RECORD OF TECHNICAL CHANGE

Technical Change No.: CAP-1

Project/Job Name: Corrective Action Plan for Corrective Action Unit 168: Area 25 and 26 Contaminated Materials and Waste Dumps

CAU 168, CAS 25-16-03
MX LANDFILL SOIL COVER

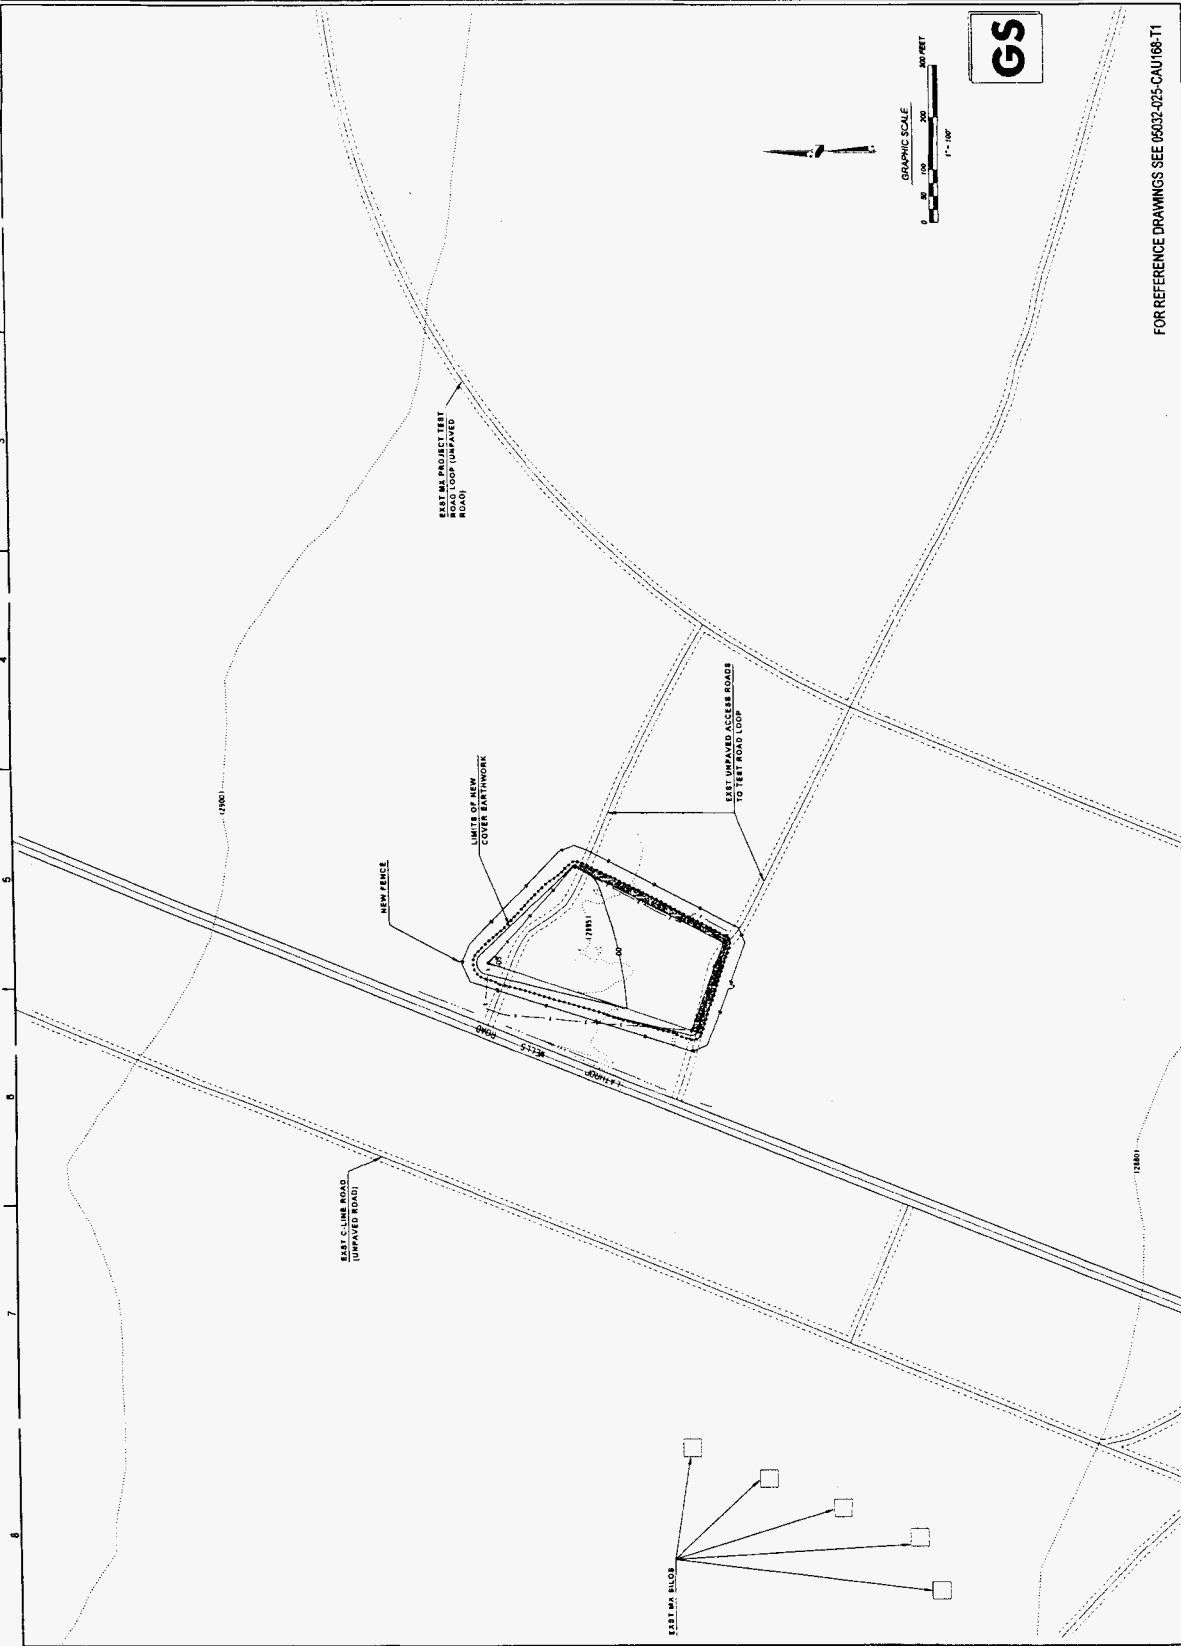
15. Appendix A.1. Include the attached engineering drawings for CAS 25-16-03.

Changes associated with CAS 25-16-03, MX Construction Landfill (Changes 2, 4, 7-10, 12, and 15): An engineered soil cover will be built instead of placing additional soil over the existing landfill. The design parameters are specified in the attached engineering drawings. The cover design is based on the following guidelines:
